Our Ref: BNE240152

Council Reference:	A006625212
Property Location:	288 Albany Creek Road, Bridgeman Downs QLD 4035
Property Descriptions:	Lot 2 on RP138914
Development:	Development Permit for a Reconfiguring a Lot 1 into 23 lots
Client:	Kenny Jap

We refer to Council's Information Request dated 8 November 2024 made under clause 12.1 of the *Development Assessment Rules* ("DA Rules") and, on behalf of our client, and pursuant to clause 13.2(a), forward the following as a **full** response to **all** requested items.

Figure 1 – Waterway Corridor and Flood Hazard Overlay

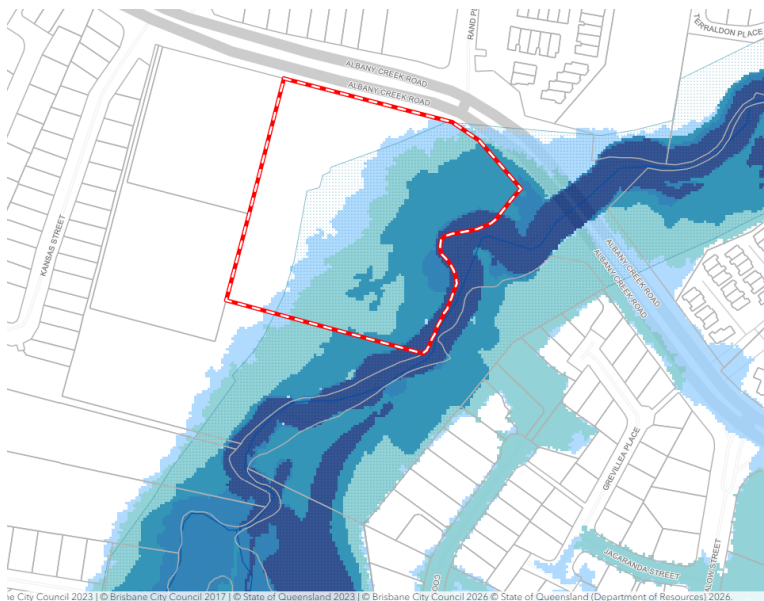
4) The majority of the site is mapped under the HES and HESS sub-categories of the Biodiversity areas overlay and within the Citywide subcategory of the Waterway corridors overlay. The site also forms part of a State Regionally Significant Corridor associated with Cabbage Tree Creek. A Terrestrial Ecological Assessment Report (prepared by 28 South Environmental) has been submitted

a) Provide an updated Proposed Development Plan that retains additional mapped values, including a 30m (minimum) wide corridor in the south-west of the site.

The waterway corridor on the site extends further into the site then the offset provided to the east of the waterway corridor, or to the south. To the south, along the same side of Cabbage Tree Creek, generally has been identified as consistent with the 1% AEP flood level, which impacts these lots, refer **Figure 1** below. However, the waterway corridor on the subject site does not align to the 1% AEP flood even on the subject site and deviates further west then the whole of the corridor to the south of the site. As identified in **Figure 2** below and the Water Technology Report (refer Figure 3-9 in **Attachment C**) and Figure 2 below, the proposed development retains the flood conveyance through the site, other than a small area in the south-east corner, predominantly for a stormwater basin. The flood modelling provided by Water Technology identifies that there are no off-site flood impacts, consistent with PO6c. of the Waterway corridors overlay code.

Figure 2 – Water Technology 1% Flood Event Peak Level Impact (1% AEP flood area affecting development footprint shown by red line)

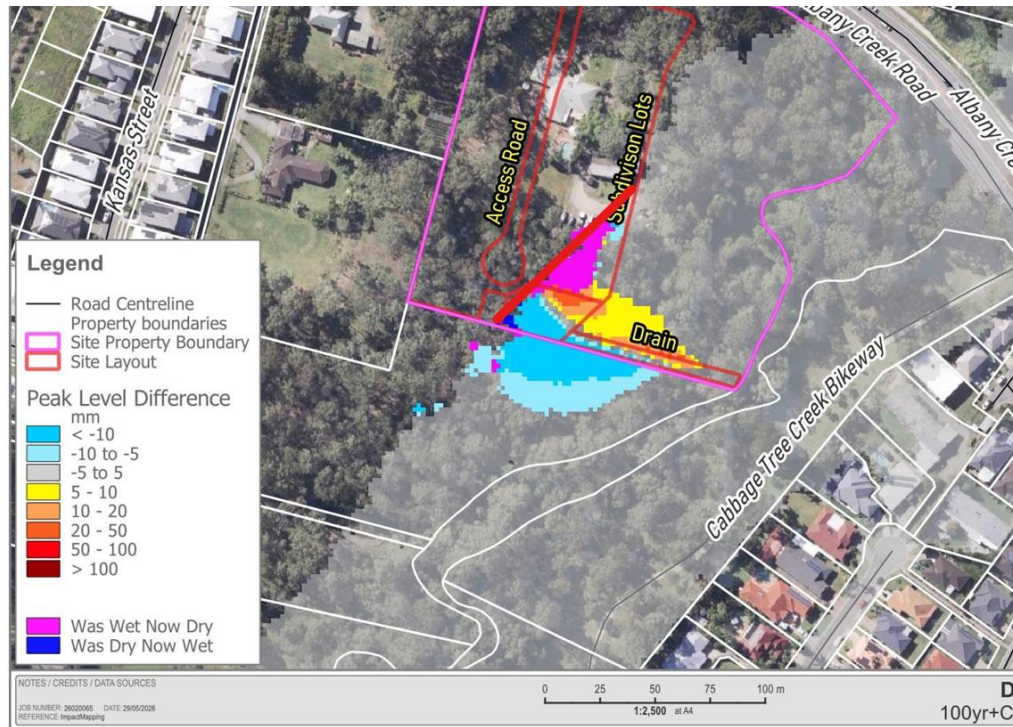
ii) Revised plans showing Lot 11 removed from the development, and a bio-retention basin provided over the area of the proposed lots 12 and 13, which are subject to inundation by 1% AEP creek flooding to maintain flood storage.

iii) The Flood Study is to show flood levels for the creek in relation to the proposed lots, consistent with the latest AR&R 2019 RCP4.5 climate change requirements to the Council flood model to produce revised flood levels OR adopt 500mm freeboard for any lot above the 1% AEP using the current Cabbage Tree Flood Study (e.g. 200mm higher than standard requirement).

A flood study has been provided by Water Technology which supports the proposed civil design, minimum floor levels, filling and excavation and basin location, refer **Attachment C** for further information.
